# ADDENDUM NO. 1

## 2015 - Installation of 3 Precast Concrete Bridges

Essex County, NY

May 28, 2015

**STREAM CHANNEL RECONSTRUCTION NOTE**

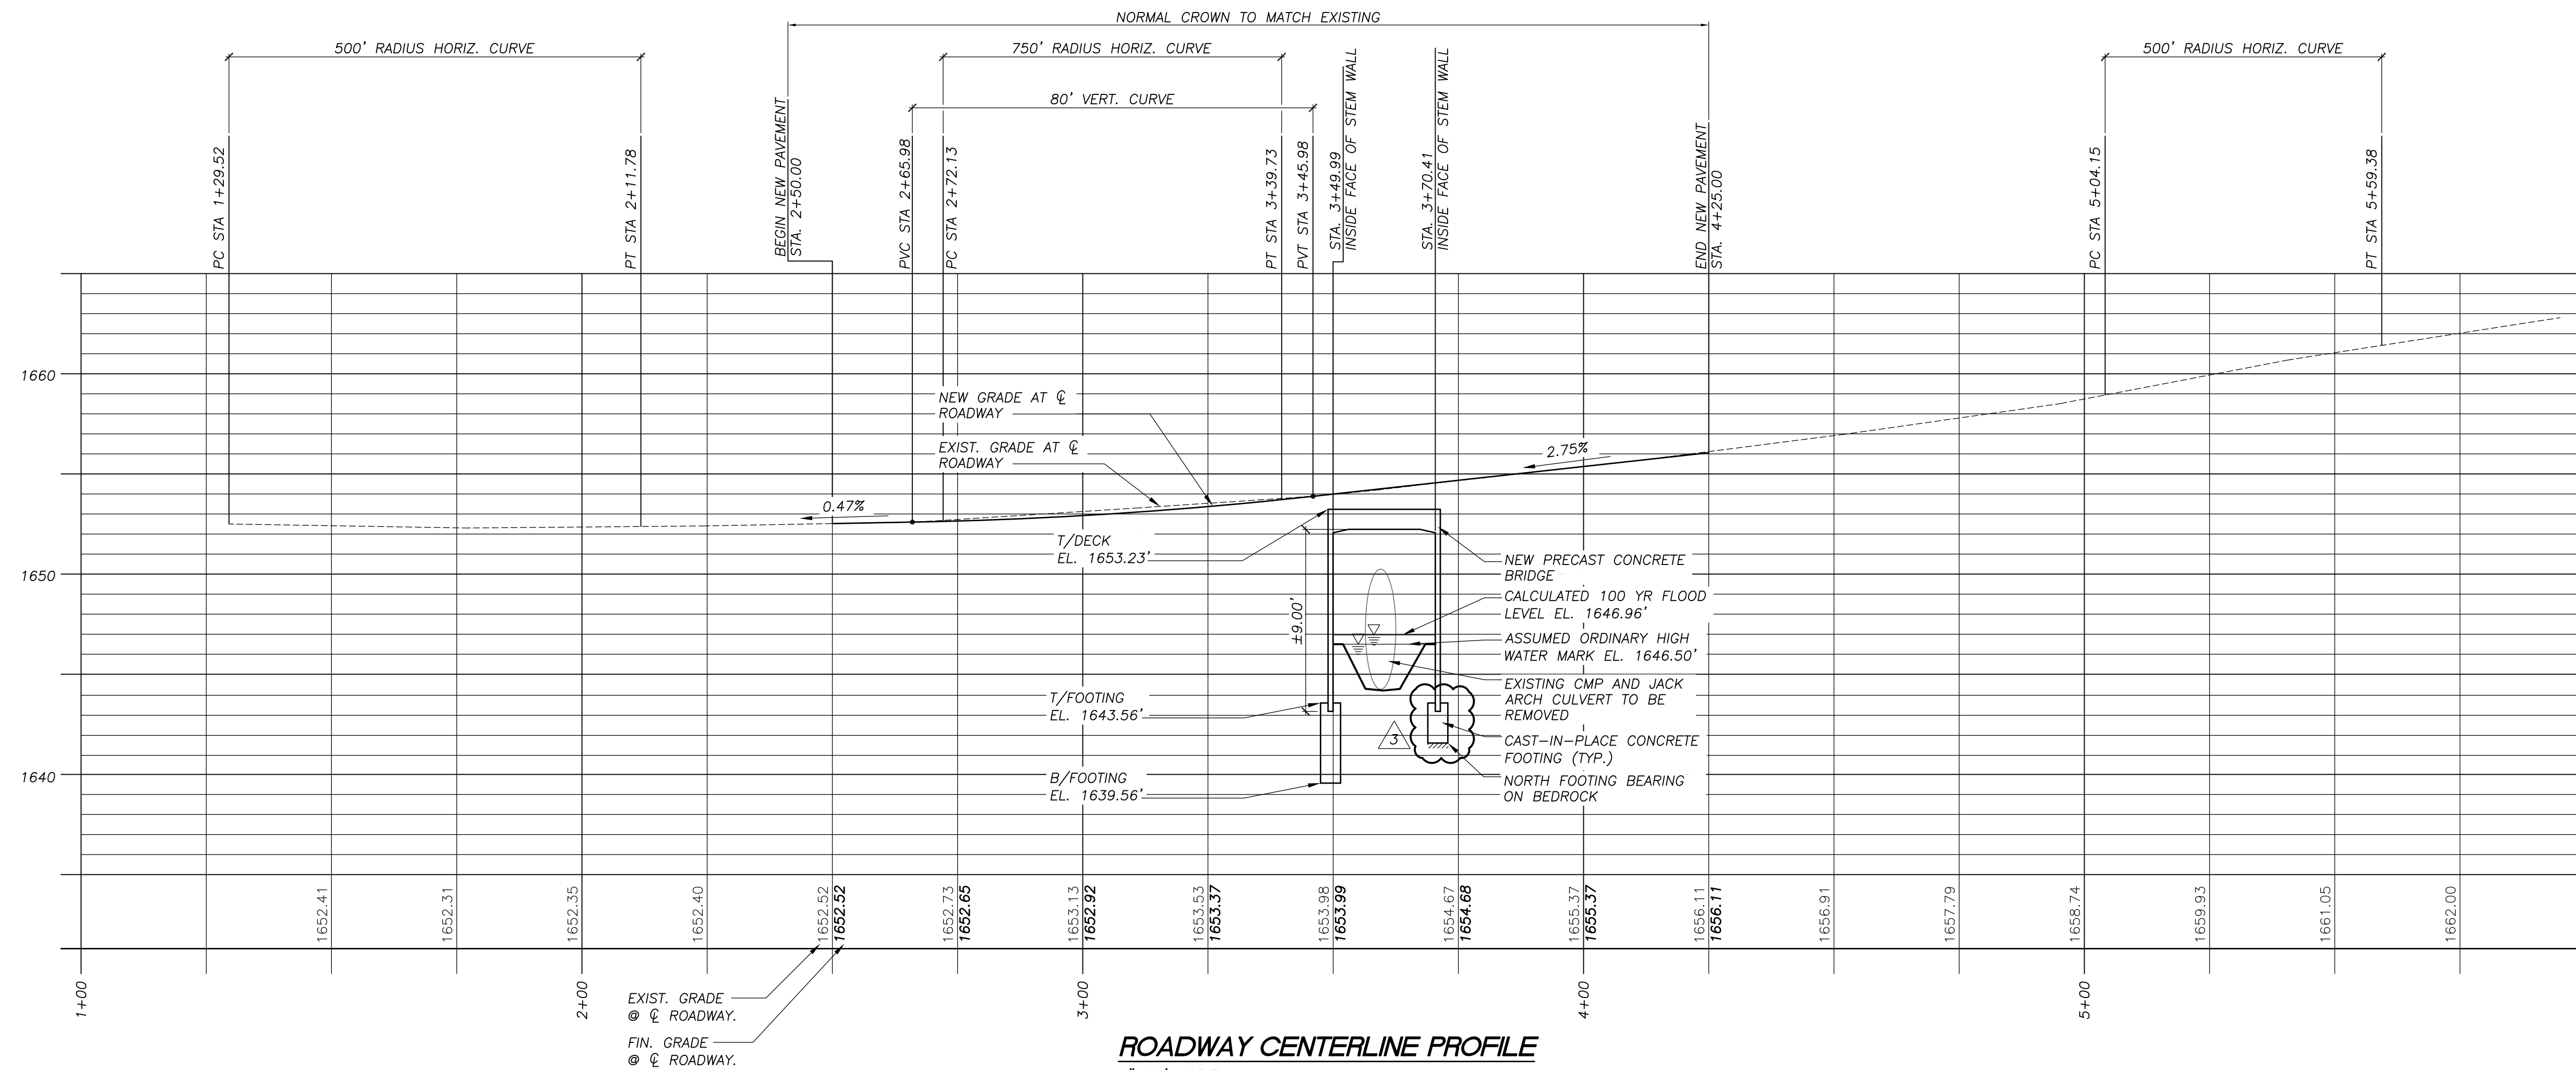
REV.	DATE	REVISIONS DESCRIPTION
0	1/19/15	ISSUED FOR REVIEW
1	2/9/15	MODS. PER TNC REVIEW
2	4/27/15	BID AND CONSTRUCTION
3	5/27/15	MODS. TO NORTH FOOTING

DRAWING NO. **C/S-1** SHT. 18 OF 21  
REV. 3

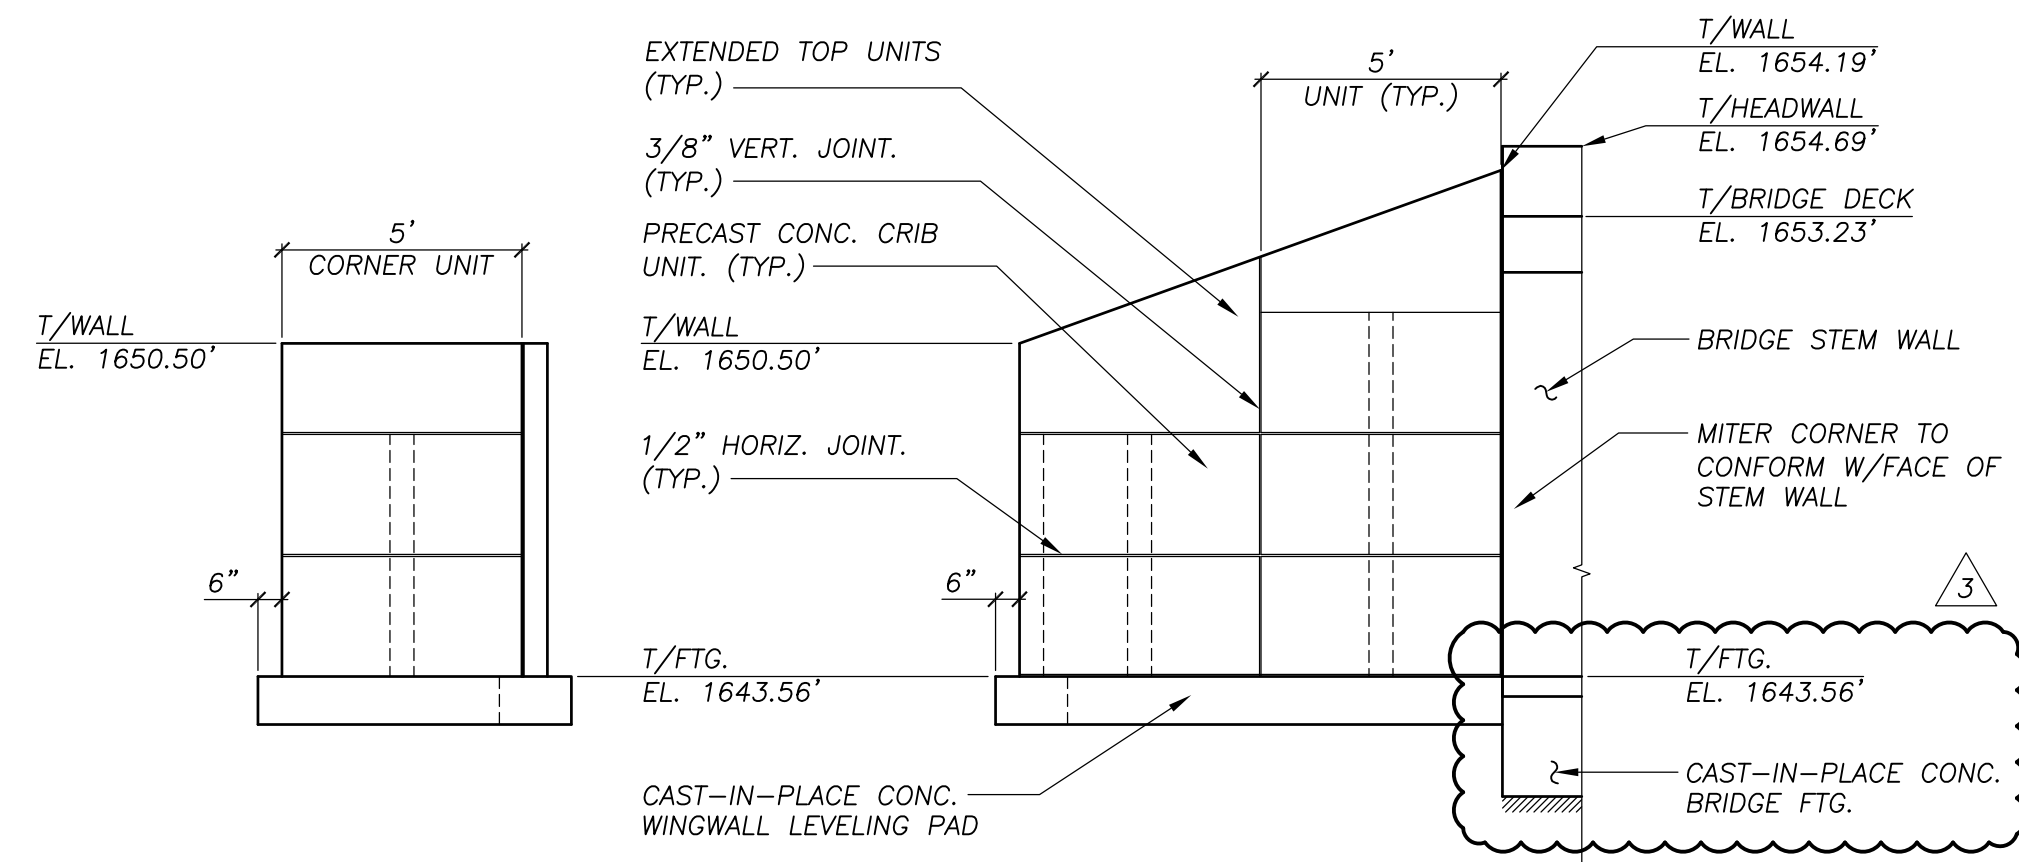
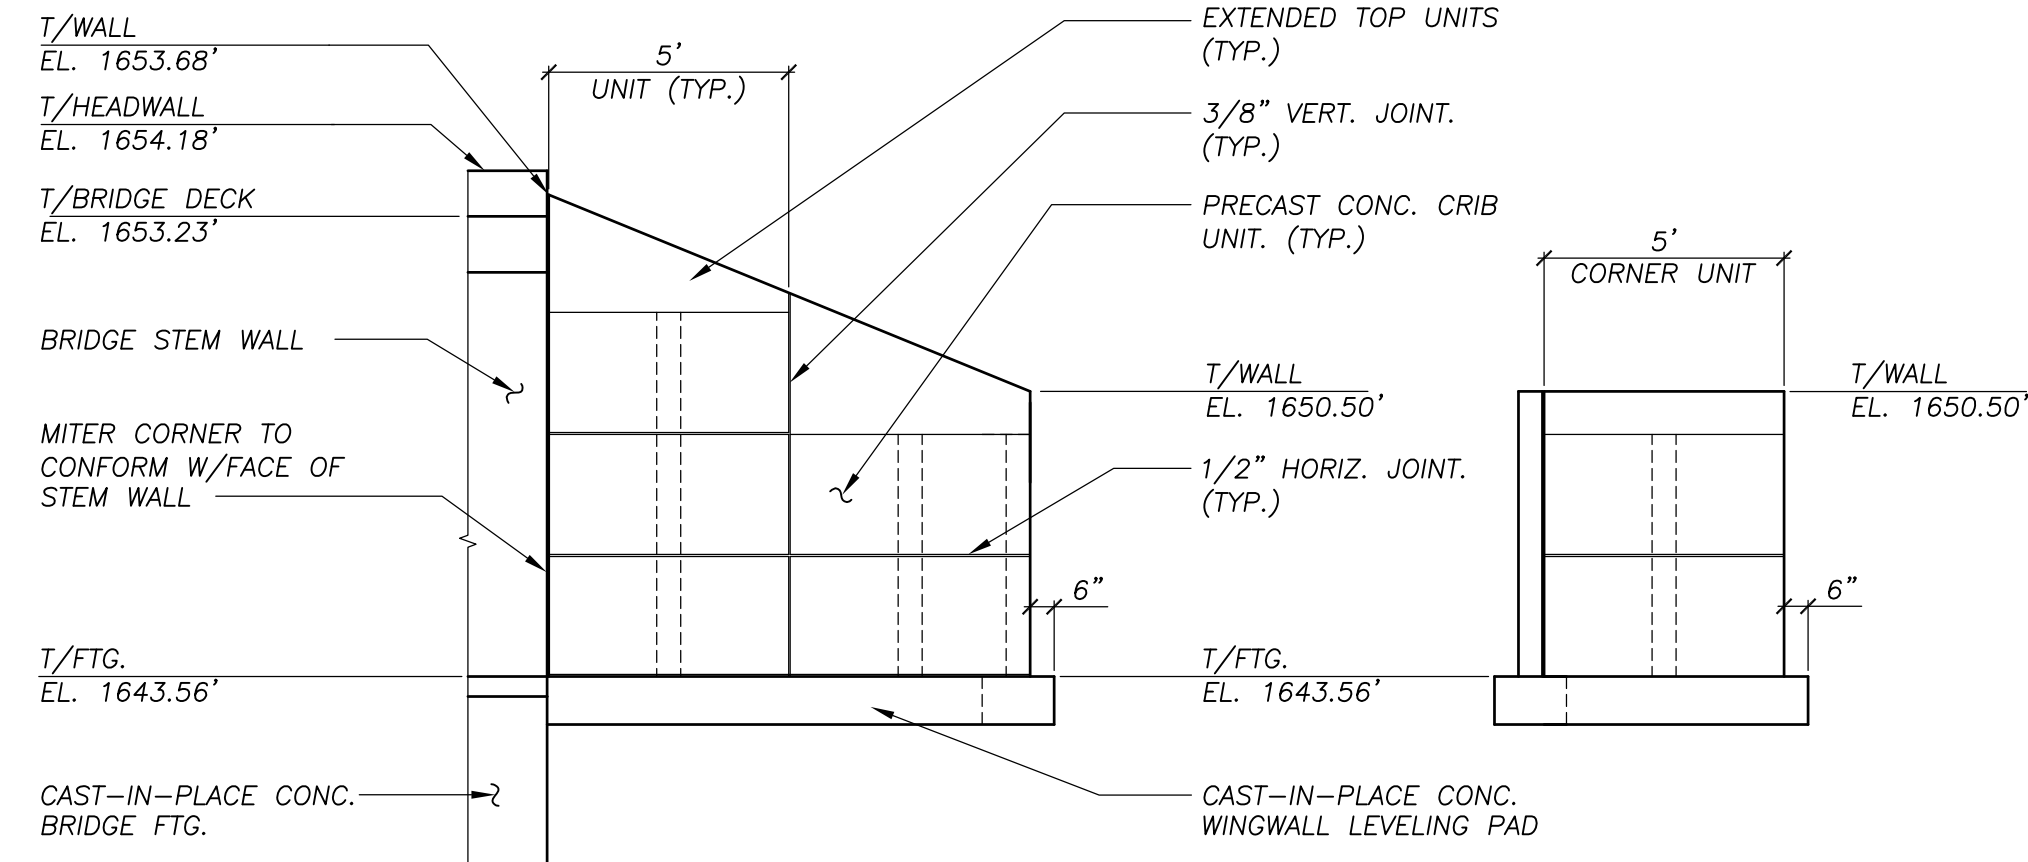
1. **General:** A Pre-Bid meeting was held for the project at the Project A (Algonquin Lane) site on May 26, 2015 at 9:30 AM. Minutes from the meeting are enclosed and are a part of this Addendum and the Contract Documents.
2. **General:** Additional soil borings were taken at the sites for Projects B & C. Revised Geotechnical Reports for these sites are attached to this Addendum.
3. **Drawings - Project B:** Drawing B/C-1 Rev. 3 is attached to this Addendum and shall replace Drawing B/C-1 Rev. 2 included in the original Bidding Documents.
4. **Drawings - Project C:** Drawings C/C-1, C/C-2, C/COE-1, C/S-1 and C/S-2, all Rev. 3, are attached to this Addendum and shall replace Drawings C/C-1, C/C-2, C/COE-1, C/S-1 and C/S-2, all Rev. 2 included in the original Bidding Documents.

REVISIONS		
REV.	DATE	DESCRIPTION
0	1/19/15	ISSUED FOR REVIEW
1	2/9/15	MODS. PER TNC REVIEW
2	4/27/15	BID AND CONSTRUCTION
3	5/27/15	MODS. TO NORTH FOOTING
